Report to the Future Melbourne (Planning) Committee

Planning Permit Application: TP-2019-834
363 King Street, West Melbourne

PLANNING REPORT

Application Number	TP-2019-834
Address	363 King Street, West Melbourne
Applicant	Gray Puksand C/- Urbis
Owner	GHK No. 2 Pty Ltd
Architect	Gray Puksand
Proposal	Partial demolition, construction of a multi-level office building and reduction in car parking provision
Cost of works	\$20,034,000
Planning Controls	Mixed Use Zone Design and Development Overlay Schedule 12 (DDO12) Design and Development Overlay Schedule 33 (DDO33) Heritage Overlay – Schedule HO841 (357-369 King St, West Melbourne) Clause 52.06 (Car Parking)
Key Planning Considerations	Demolition Heritage impacts Built form and urban design Use of the land for office. Amenity impacts Sustainability Traffic
Public Notice	Sign(s) posted on-site and letters sent to adjoining property owners/occupiers
No. of Objections	22
Key Issues raised by objectors	Built Form, including scale, setbacks and appearance Heritage impacts Amenity impacts, including daylight loss, overshadowing & overlooking Traffic impacts Construction impacts

Figure 9 - Extent of proposed demolition. From Drawing S010

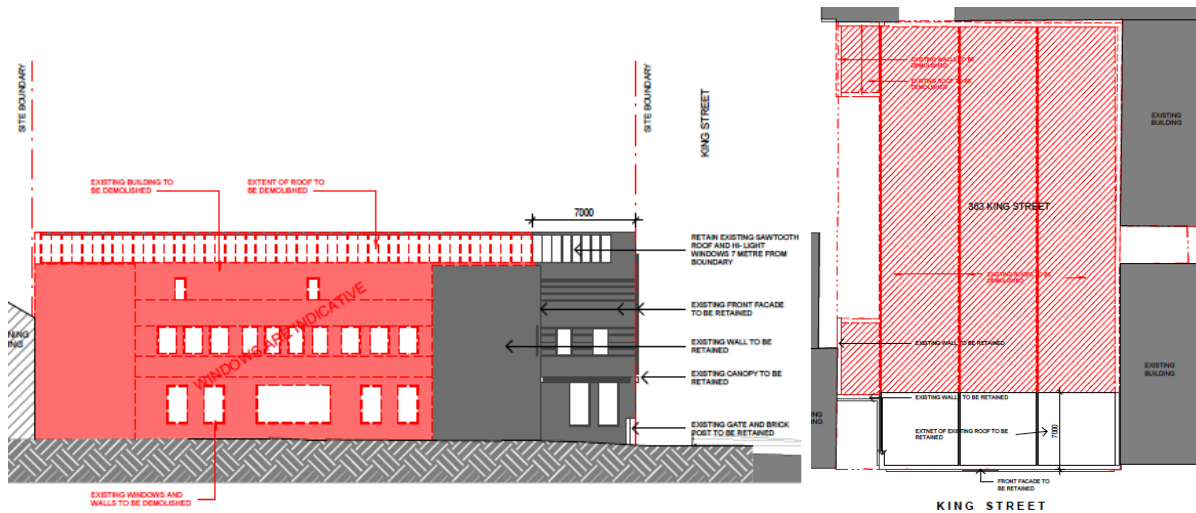
The proposal, as depicted in Figure 9 would involve the retention of at least the front seven metres of the heritage building, with the front 13.6 metre section of the southern wall also retained. All other building fabric, including the majority of internal walls, in addition to small sections of the front façade, would be removed to accommodate the proposed development.

Council's Heritage Advisor is generally supportive of the extent of demolition, though raised concerns in relation to the extent of demolition of the sawtooth highlight glazing element above the retained section of wall along the southern elevation. As evidenced by the photo at Figure 10, the section of highlight window referred to in the heritage advice is clearly visible from the La Trobe and King Street intersection.

Figure 13 - 22 June Shadow Diagram at 2pm. From Drawing S326

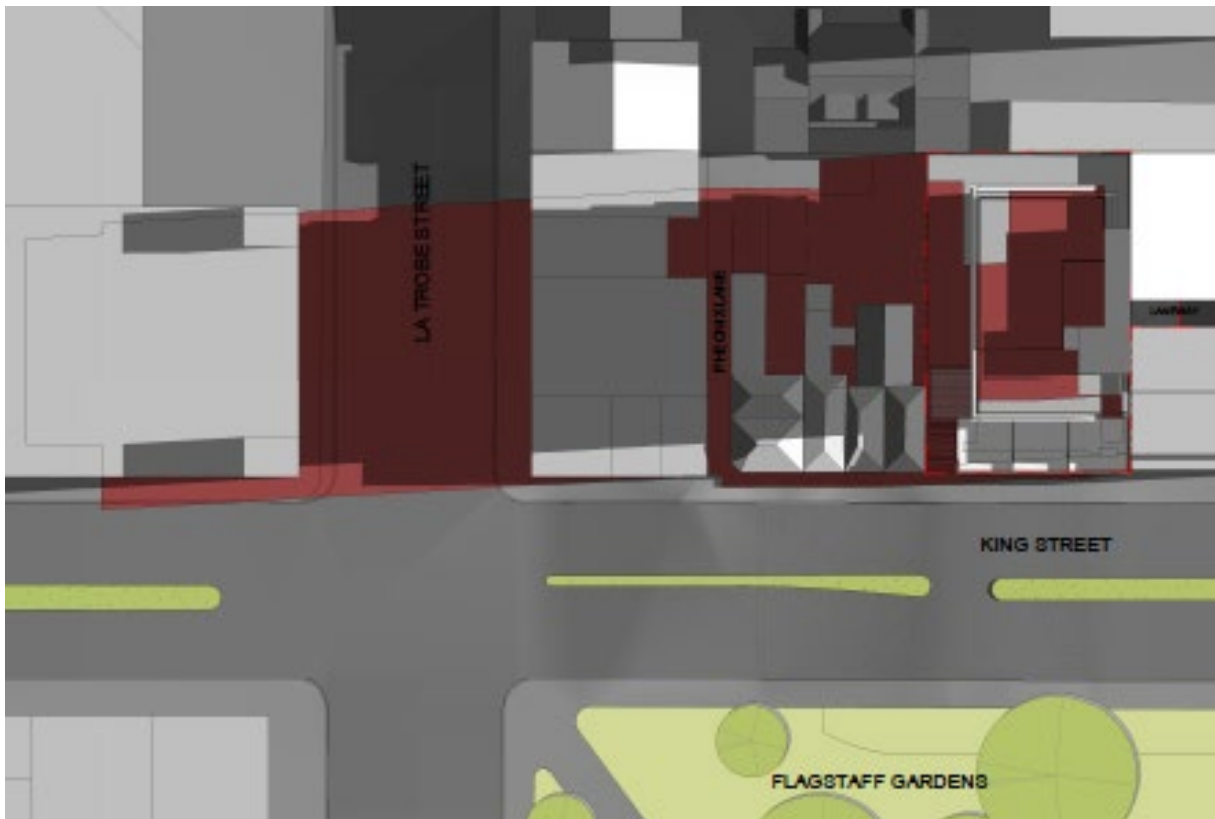
Overshadowing	Development does not overshadow Flagstaff Gardens between 11am and 2pm on 22 September and 22 June.	Proposal does not overshadow Flagstaff Gardens between 11am and 2pm on 22 September and 22 June (refer to Figure 13).
Frontages	Provide active frontages at the ground floor where appropriate particularly along Spencer, King, Dudley and La Trobe Streets.	Two separate commercial tenancies are proposed along the King Street frontage. The existing building entry would be demolished to create an at-grade connection.
Loading and Services	To be located along laneways where possible.	Loading and unloading, including waste collection would be via the private laneway. All services other than Fire Boosters are located away from the building frontage. In response to a request from Council, a letter provided by WSP confirms that: <i>“... the building services, as proposed, is likely to be sufficient to service the development, and the design will accommodate the access requirements of the relevant authorities, subject to further design development and co-ordination post planning permit stage.”</i>

As outlined above, the proposal achieves a high level of compliance with the Built Form Outcomes and Requirements of the revised DDO33. The only requirement which would require a variation is the side and rear setbacks, which remain largely unchanged from the current controls.

Figure 16 - September 22 Shadow Diagrams at 11am (left) and midday (right). From Drawing S321

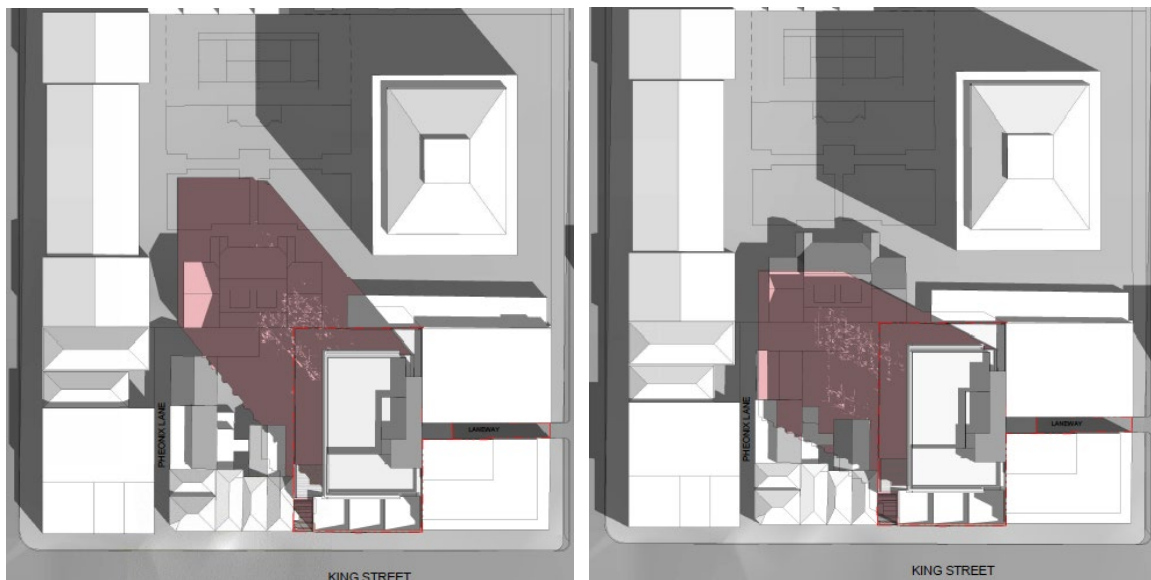
The Shadow Diagrams submitted as part of the application confirm that this area of communal open space would receive additional overshadowing between 9am and some time before midday (refer Figures 15 & 16).

A review of the above shadow diagrams confirms that the proposal would have a substantial shadow impact on this adjacent area on the Equinox during the morning period. The shadow diagrams do, however, demonstrate that large areas of communal open space would be unaffected throughout the entire day. Furthermore, the greatest extent of overshadowing is a result of the existing 14 storey building which forms part of the 'Royal Flagstaff' complex.

Based on the above, it is considered that, while the proposal will have an adverse shadowing impact on the communal open space to the west, it is not unreasonable in an inner city context where robust buildings of the type proposed are encouraged by the Melbourne Planning Scheme.

Figure 17 - Proposed Site Plan (Drawing S022), depicting adjacent habitable room windows

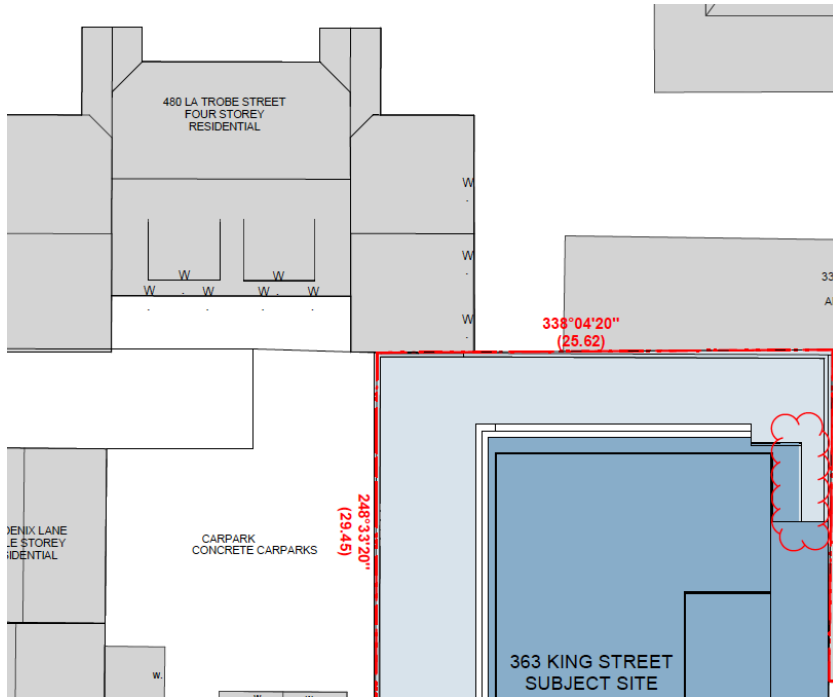
The Melbourne Planning Scheme does not include any overlooking controls for commercial buildings. Notwithstanding, the subject site adjoins a residential property, which has areas of communal open space and windows within close proximity of the common boundary. Privacy and overlooking is therefore a relevant consideration.

In order to minimise the extent of overlooking into the adjacent habitable room windows, levels 1, 2 and 3 of the building have obscure glazing to a height of 1.7 metres where they are within close proximity (refer Figure 18).

Figure 18 - Proposed West Elevation showing extent of obscure glazing. From Drawing S302

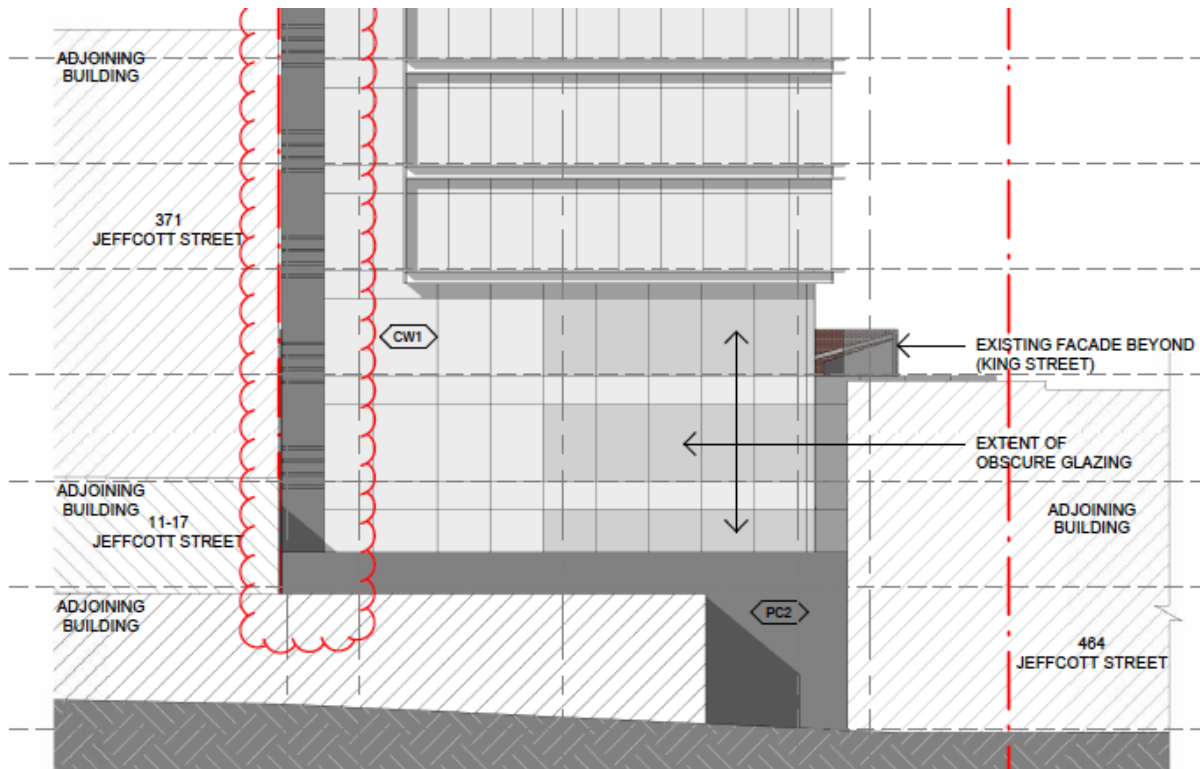
Given the lack of overlooking controls for commercial buildings, minimum 5.1 metre setbacks at levels 1-3 and use of obscure glazing on these levels, it is considered that overlooking into adjacent habitable room windows is adequately mitigated.
